《混凝土結構作業守則 2013 年（2020 年修訂版）》
修訂事宜

Amendments to the Code of Practice for Structural Use of Concrete 2013 (2020 Edition)
(February 2022)

Amendments to the Code of Practice for Structural Use of Concrete 2013 (2020 Edition)

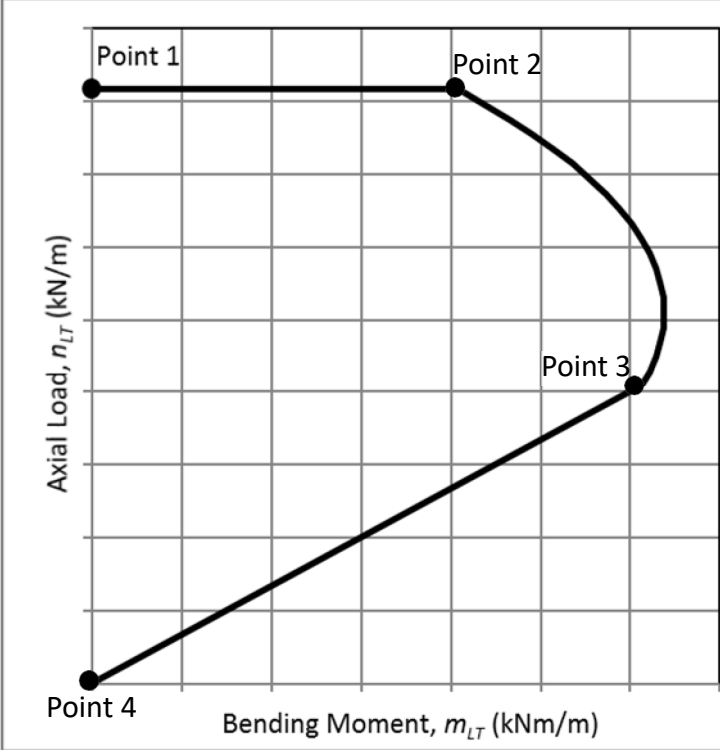
4. Clause 6.2.3 and Figure 6.18b	-	6.2.3 Plain concrete linings 6.2.3.1 General Plain concrete is suitable for use in structural members with high axial loads and relatively low bending moments. The following criteria can generally be applied to the use of plain concrete lining in tunnels or caverns: (a) the lining curvature is adequate to accommodate axial distribution of external loads; (b) the plain concrete lining is constructed in relatively good rock geology and is always in compression under all load combinations; (c) the effect of imperfection of the concrete lining has been considered by means of rigorous structural analysis of the plain concrete lining; and

Item	Current version	Amendments
		<p>(d) an arch section can be formed by plain concrete in conjunction with a reinforced concrete invert provided the junction between the plain and reinforced concrete satisfies the design requirements specified in clause 6.2.3.2.</p> <p>6.2.3.2 <i>Design of plain concrete lining</i></p> <p>(a) Maximum axial load for plain concrete lining The design ultimate capacity of axial load per unit length, n_{LT} and design maximum ultimate bending moment per unit length, m_{LT} ($=n_{LT} e_x$) shall be evaluated using the interaction curve as shown in Figure 6.18b.</p> <p>(i) The first section (Point 1 to Point 2) of the interaction curve as shown in Figure 6.18b, the highest axial force, is applicable when the eccentricity of the thrust force is less than or equal to $0.1h$. The ultimate capacity is calculated using a rectangular stress block over the whole section; For $e_x \leq 0.1h$ $n_{LT} \leq 0.32h f_{cu} \quad 6.63a$</p> <p>(ii) The second section (Point 2 to Point 3) of the interaction diagram is based on a rectangular stress block approach and is applicable for eccentricity between $0.1h$ and $0.3h$. The stress block is acting over part of the section, and reduces as the eccentricity increases. For $0.1h < e_x \leq 0.3h$ $n_{LT} \leq 0.4 (h - 2 e_x) f_{cu} \quad 6.63b$ where:</p>

Item	Current version	Amendments
		<p>e_x is the resultant eccentricity of load at right angles to the plan of the lining.</p> <p>(iii) Cracking restriction limits the use of the strength design method to a maximum eccentricity of $0.3h$. The third section (Point 3 to Point 4) of the interaction curve is a straight line down to the point $n_{LT} = 0$, $m_{LT} = 0$, as shown in Figure 6.18b.</p>  <p>Figure 6.18b – Interaction Curve for Design of Plain Concrete Lining</p>
